Index 676-010 Cabinet Installation Details

COMMENTARY

COMMENTS AND RESPONSES

LAST REVISION 11/01/22	DESCRIPTION:	 FY 2023-24 STANDARD PLANS	CABINET INSTALLATION DETAILS	INDEX 676-010	SHEET 1 of 3
---------------------------	--------------	----------------------------------	------------------------------	------------------	-----------------

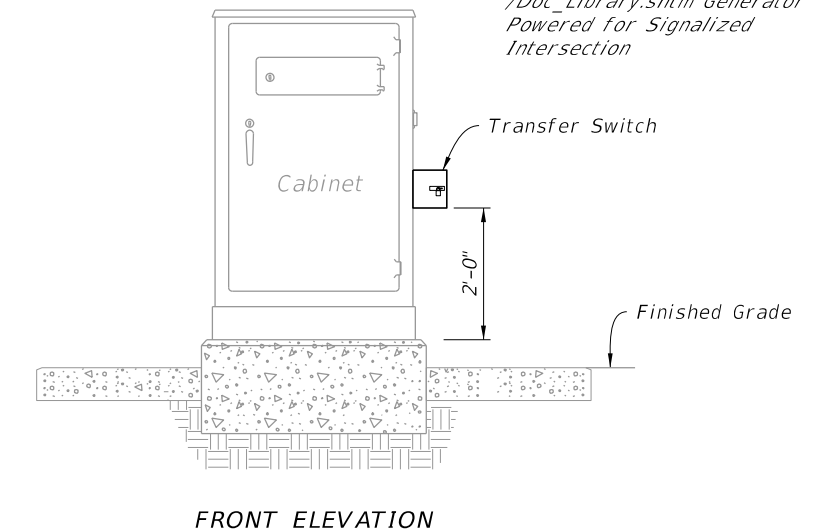
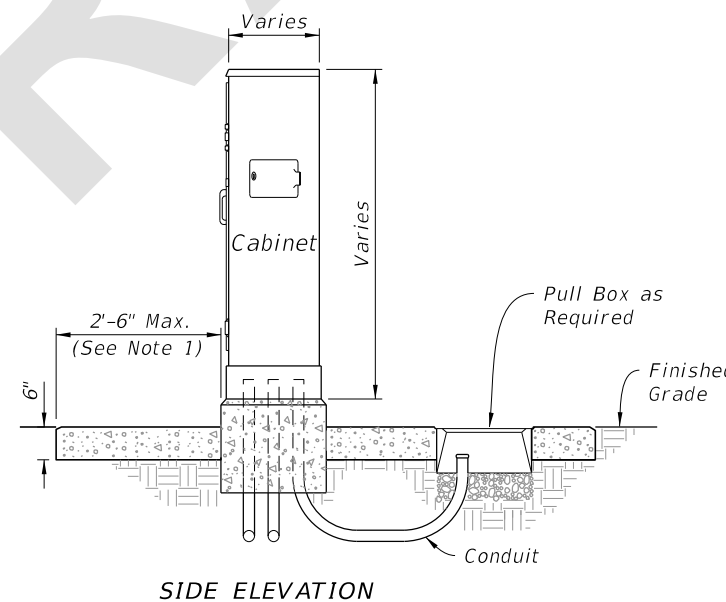
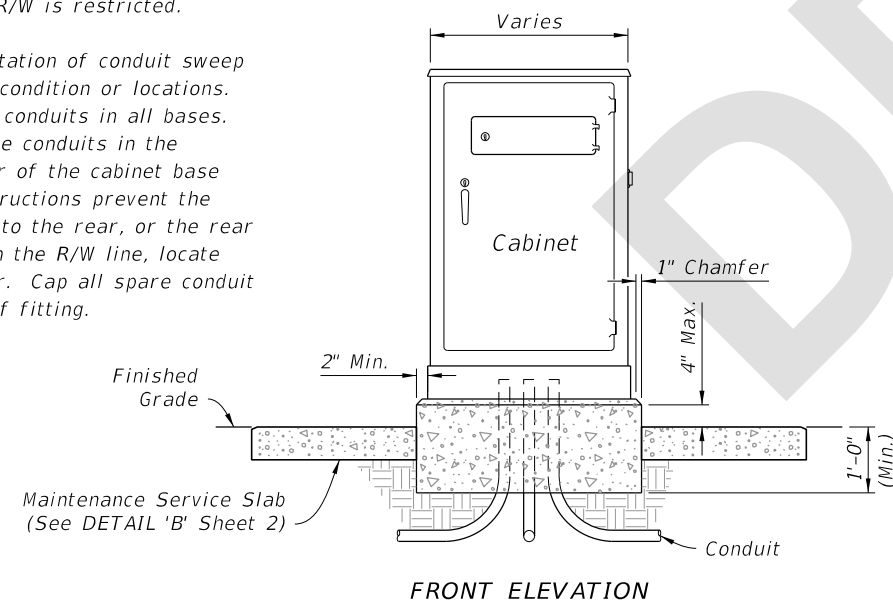
1. Sht 1/3 Note 2, typo in signalized.

2. For the maintenance pads and cabinet pads, where is the class of concrete, reinforcing, and required cabinet anchors (size/embedment/etc) addressed?

RESPONSE: Agree

CHANGE MADE TO INDEX: Update note 2

RESPONSE: Recommend updating note #1 for both pole mount and ground mount with something like Note 2 on 635-001: "Maintenance Service Slab: use Class NS concrete and slope...". 995-11.2.8 defines mounting hardware to be supplied with cabinets (we may also consider adding/moving this to 676-3.2.2).

CHANGE MADE TO INDEX: Update Notes 1 on sheet 1 and 2.

LAST REVISION 11/01/22	REVISION	DESCRIPTION:	 FY 2023-24 STANDARD PLANS	CABINET INSTALLATION DETAILS	INDEX 676-010	SHEET 2 of 3
---------------------------	----------	--------------	---	------------------------------	------------------	-----------------

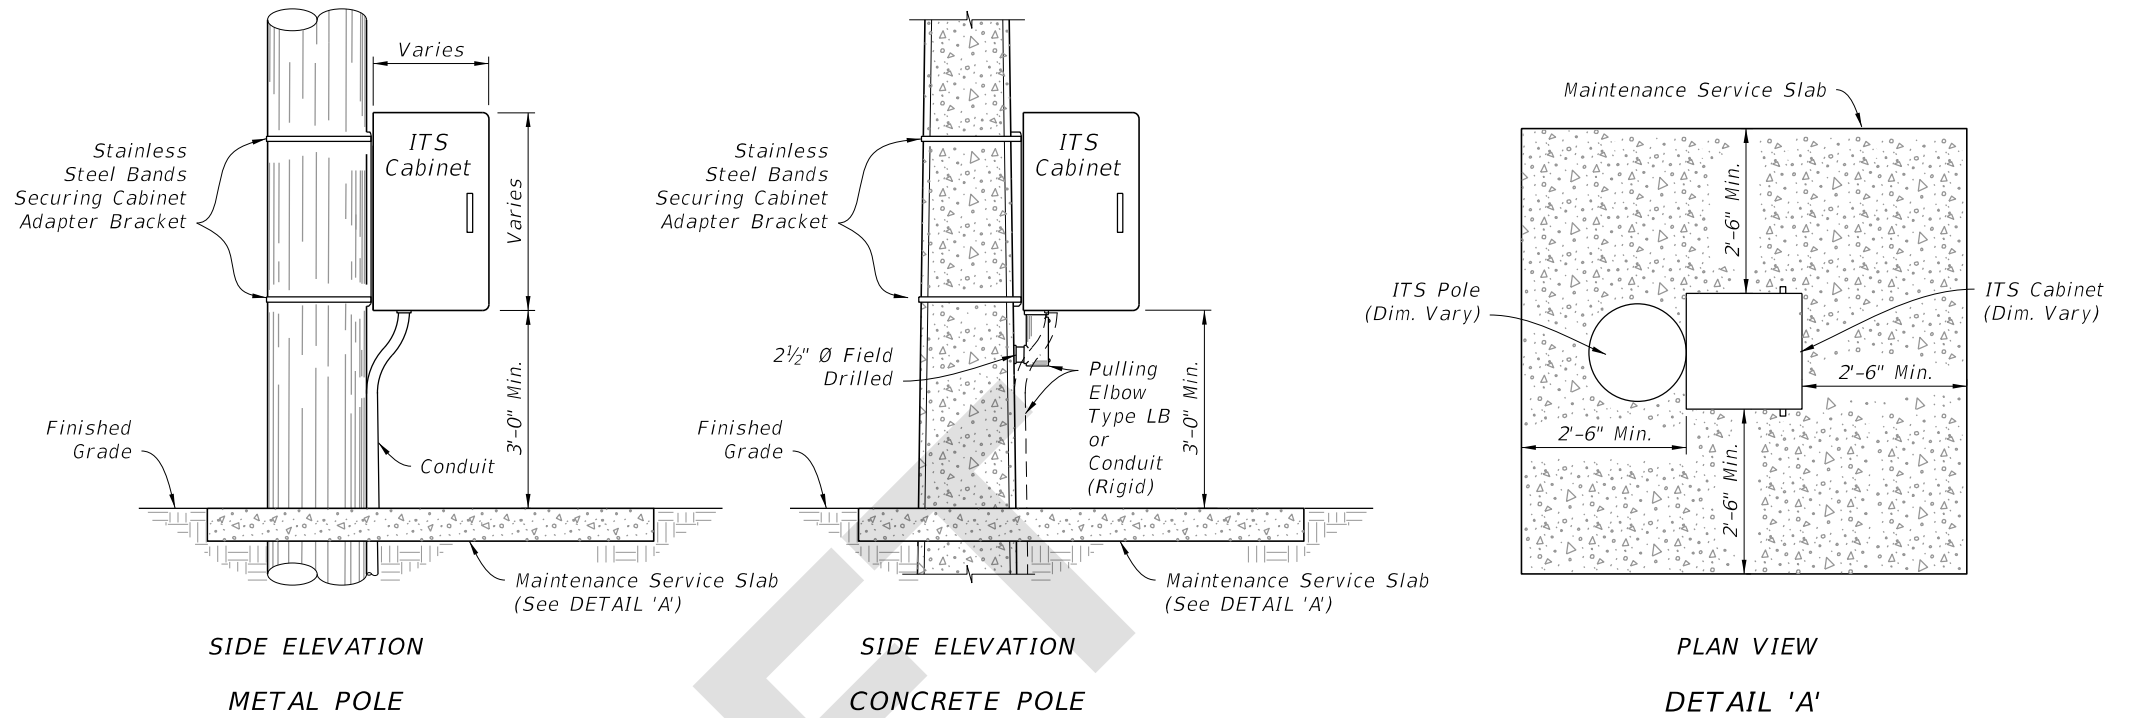
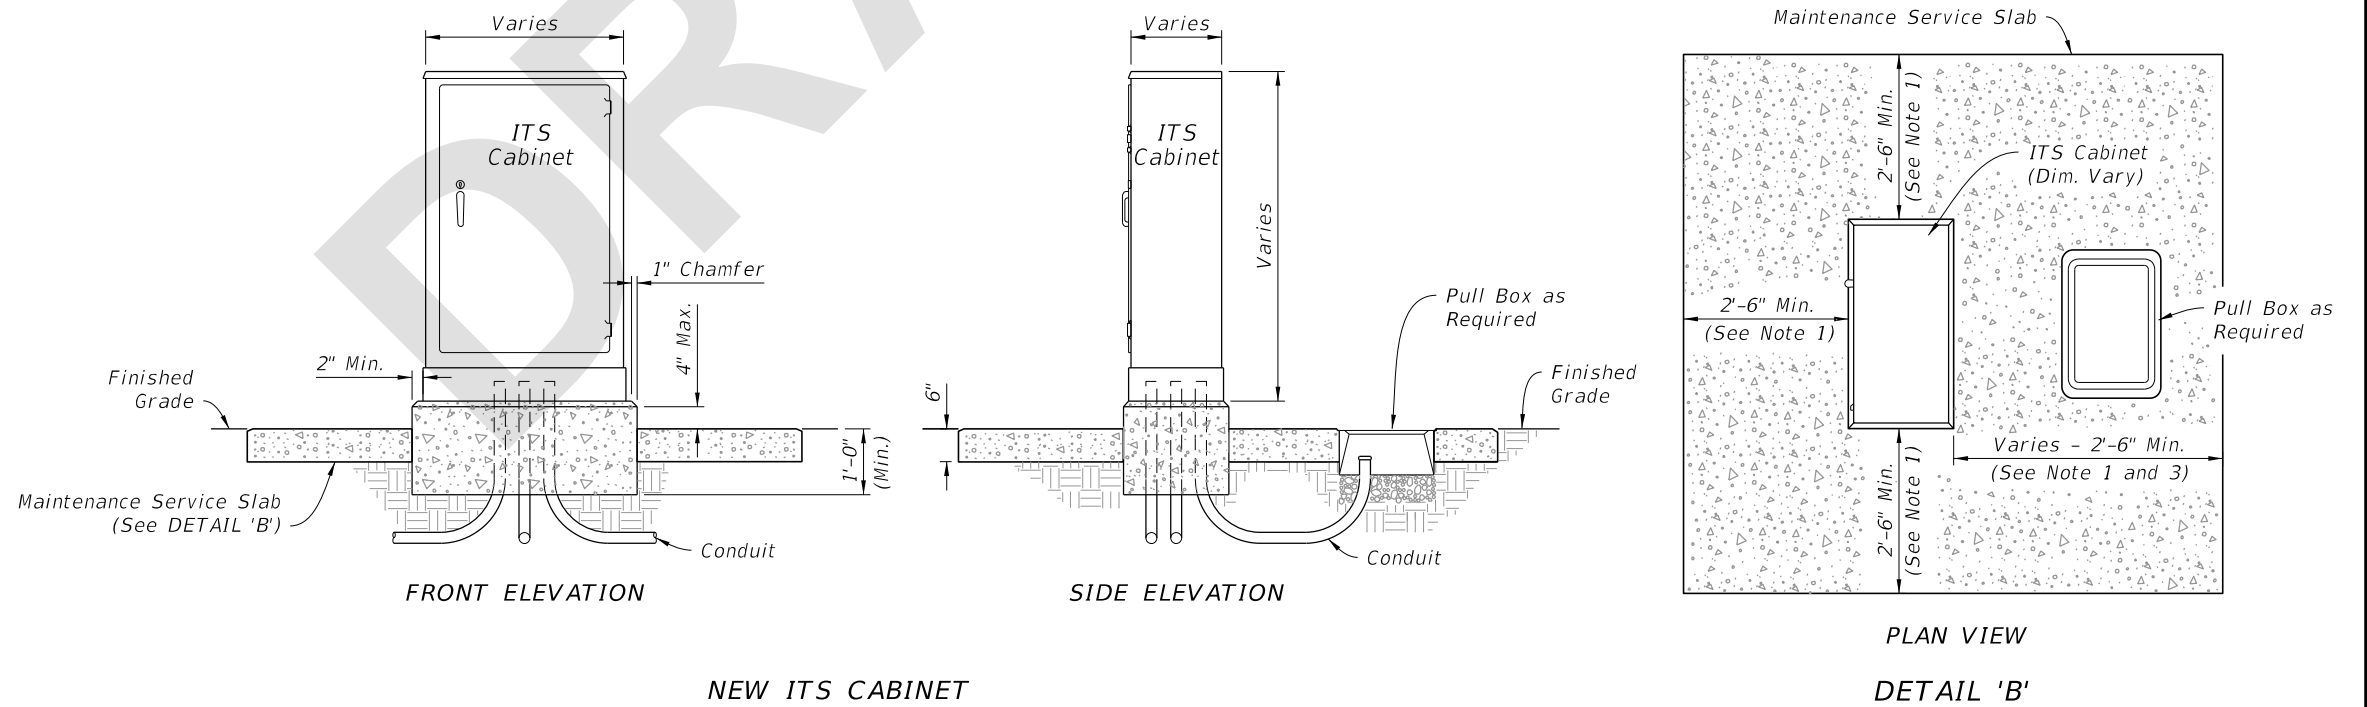
3. Sht 2/3 Notes (5 upper and 4 lower) indicate to provide a level working area and tie into proposed embankment by grading and compacting the slope. This will only be feasible for shallow slopes, yet these maintenance pads are required on slopes up to 1:2. Please address what to do for steeper slopes.

RESPONSE: Treatments for steeper slopes that may require railing, retaining walls, etc. should be addressed in project plans as needed.
